Interoperability with a One-Step Clock on Receive in 802.1ASbt Revision 1

Geoffrey M. Garner
Consultant

IEEE 802.1 AVB TG
2014.01.15

New MDSyncReceive State Machine

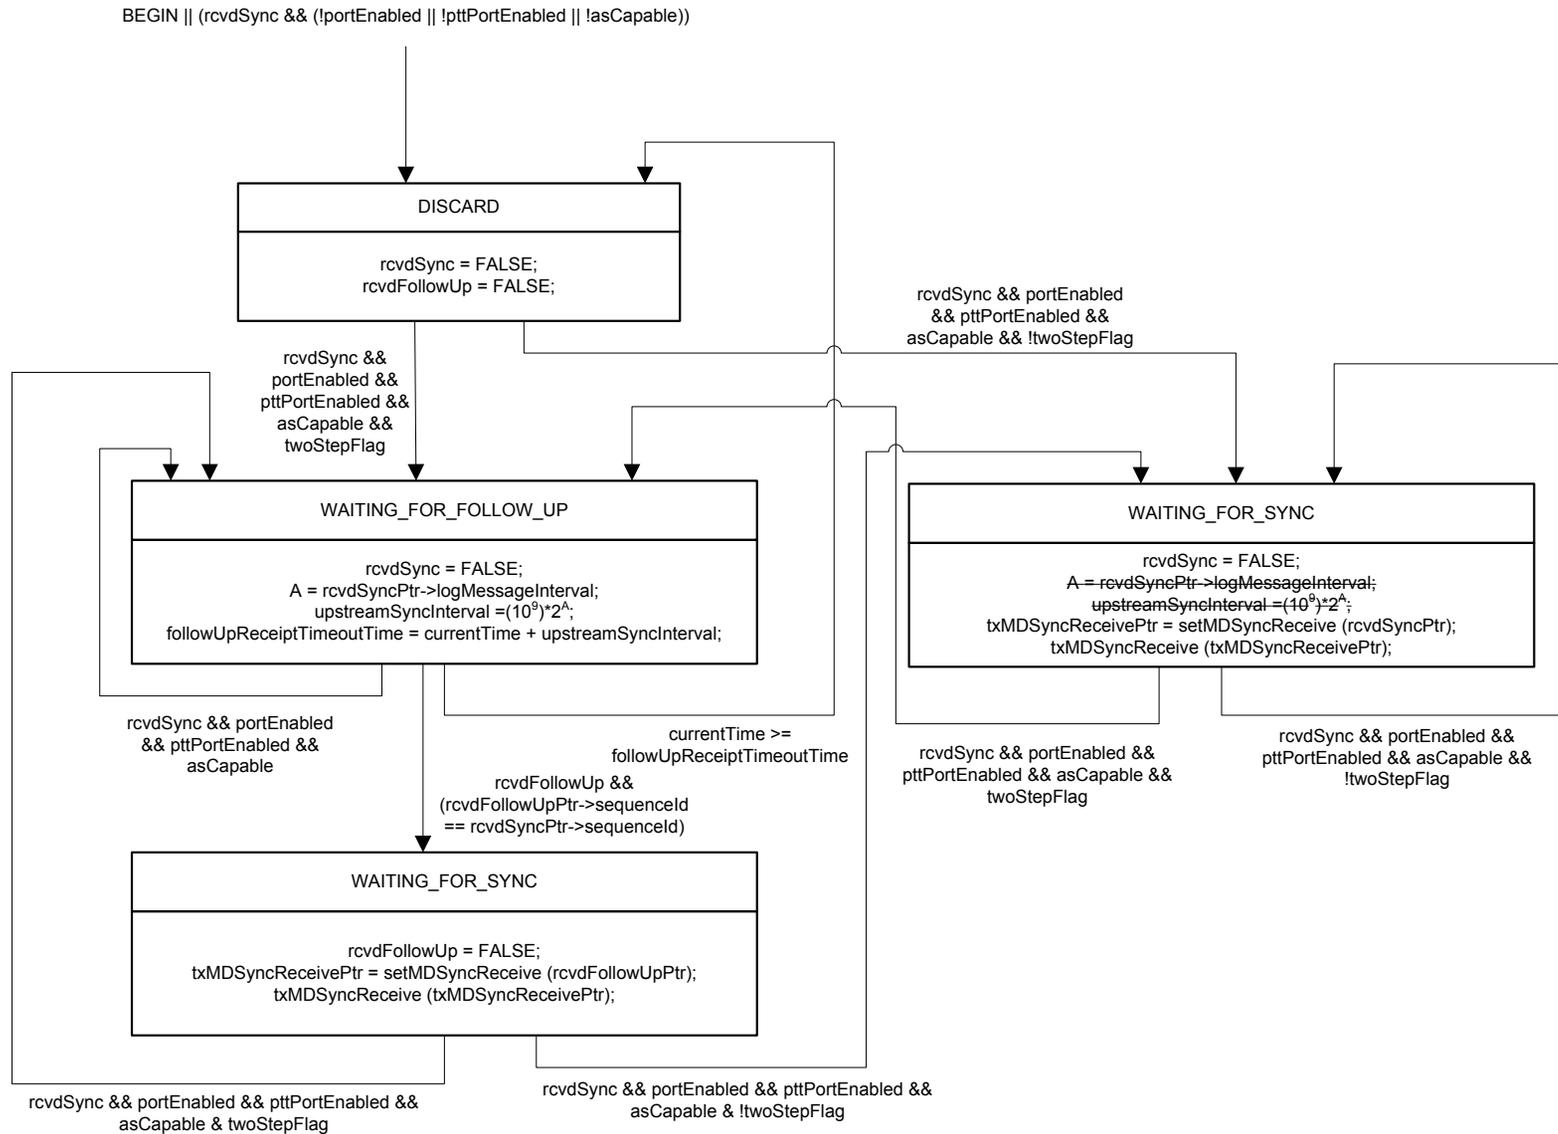
- ❑ In MDSyncReceiveSM state machine (11.2.13 and Figure 11-6), need to add logic for case where twoStepFlag is FALSE
 - If twoStepFlag is FALSE, do not wait for Follow_Up; process the correctionField in Sync as the Follow_Up correctionField would be processed.

- ❑ If twoStepFlag is TRUE, the correctionField of Sync should be added to the preciseOriginTimestamp and correctionField of the Follow_Up message to obtain the GM time when the Sync message was transmitted from the next node upstream
- ❑ In the MDSyncReceive state machine, step (a) of the function setMDSyncReceive() must set the followUpCorrectionField member of the MDSyncReceive structure equal to the sum of the correctionFields of the most recently received Follow_Up message and the corresponding most recently received Sync message (the present function sets this member equal to the correctionField of the most recently received Follow_Up message)
- ❑ MDSyncSendSM state machine does not change, as messages are sent as two-step
